Commonwealth Edison

November 17, 1989

Subject: Byron Station Unit 2
Application for Amendment to Facility
Operating License NPF-66
NRC Docket No. 50-455

Subject: Byron Station Units 1 and 2
Supplement to Application for Amendment
to Facility Operating Licenses Nos. NPF-37 and NPF-66
NRC Docket Nos. 50-454 and 50-455

FIGURE 3.4-2a

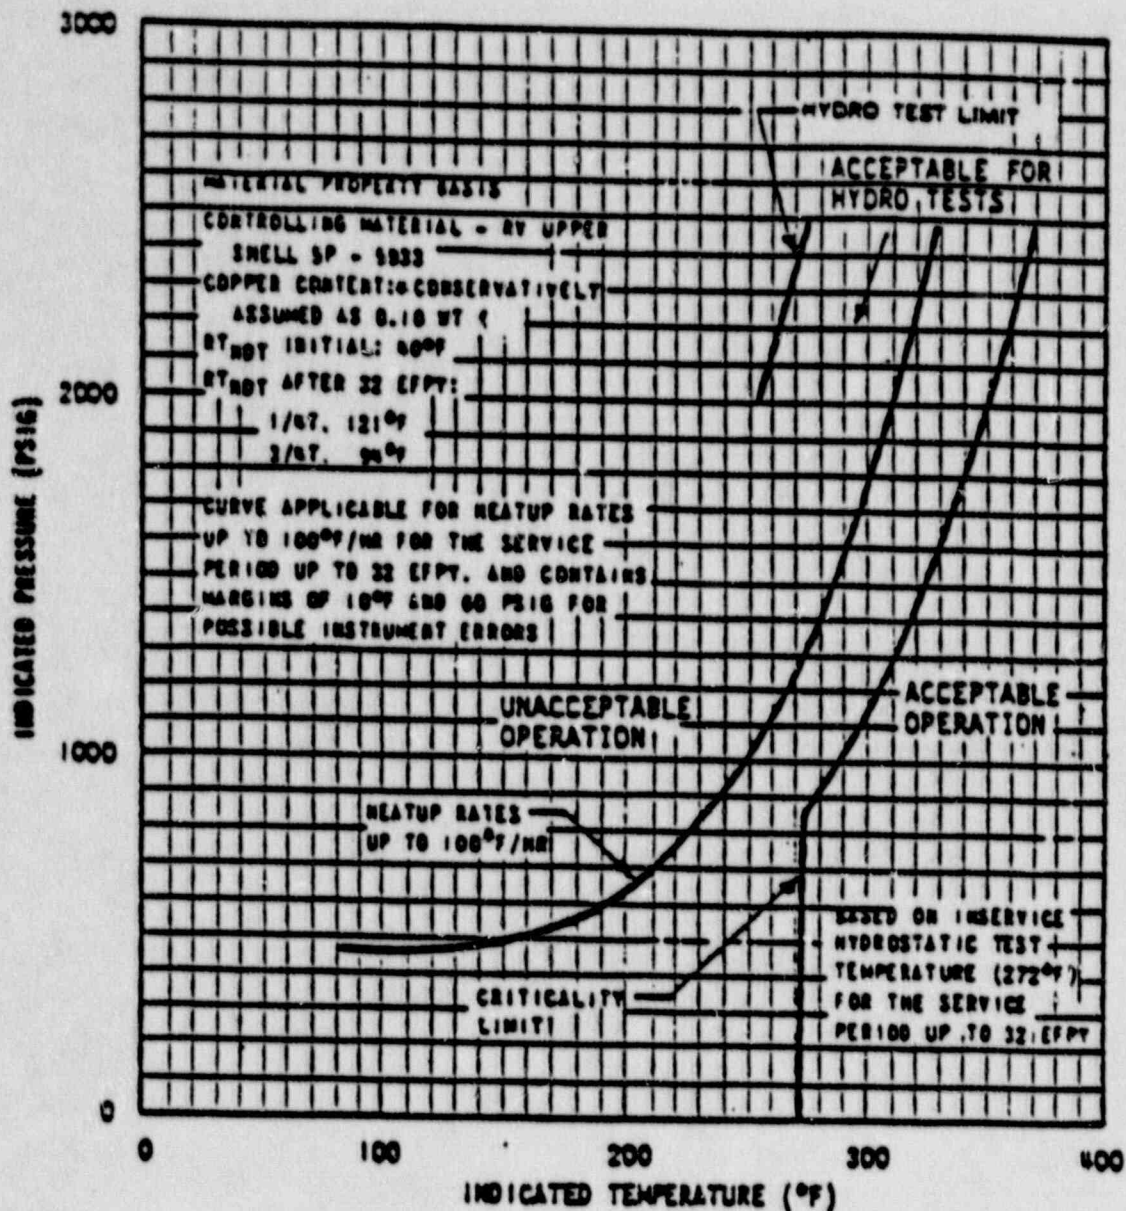
In reference (a), pursuant to 10 CFR 50.90, Commonwealth Edison proposed to amend Appendix A, Technical Specifications of Facility Operating License NPF-66. The proposed changes to the Technical Specifications included requested changes to Byron Unit 1 Reactor Coolant System Heat-up Limitation Curve, Figure 3.4-2a, to incorporate a reduced applicability limitation. Therefore, we wish to also amend Facility Operating License NPF-37 to include the previously requested revision to Figure 3.4-2a.

Additionally, in response to NRC questions posed during a December 20, 1989 phone conversation, we wish to change the proposed change to Figure 3.4-2a to incorporate further clarification of curve applicability. The calculations performed per Regulatory Guide 1.99 Revision 2, which resulted in the applicability limitations to 29.5 EFPY (Reference 2), utilized actual copper content of 0.05 Wt. % instead of the conservative 0.1 Wt. % of the existing curve. The new proposed change to Figure 3.4-2a provides further clarification of this applicability limitation. This change to Figure 3.4-2a, Technical Specification page 3/4 4-33, is attached.

*Applicability date has been reduced per Regulatory Guide 1.99 Rev. 2 to 29.5 EFPY. The calculation to determine applicability utilized actual copper content of 0.05 Wt%.
